# 190827613 Thunderboard Sense SLTB001A End of Life (EOL)

**Bulletin Issue Date:** 8/27/2019

Existing Part #  
SLTB001A  
BRD4160A

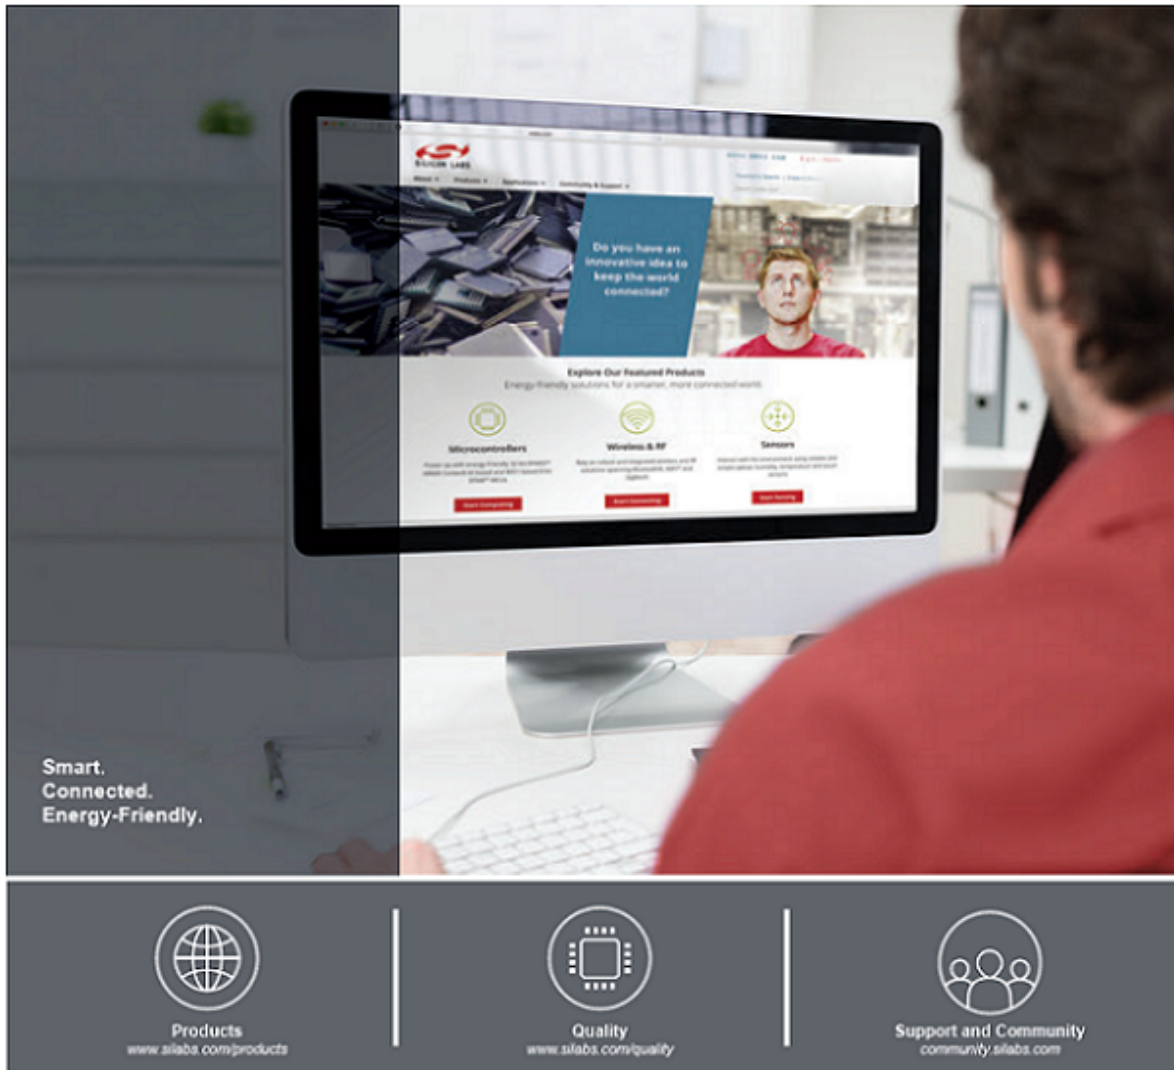
Silicon Labs announces an End of Life (EOL) for Thunderboard Sense SLTB001A.

Replaced by Thunderboard Sense 2 SLTB004A.
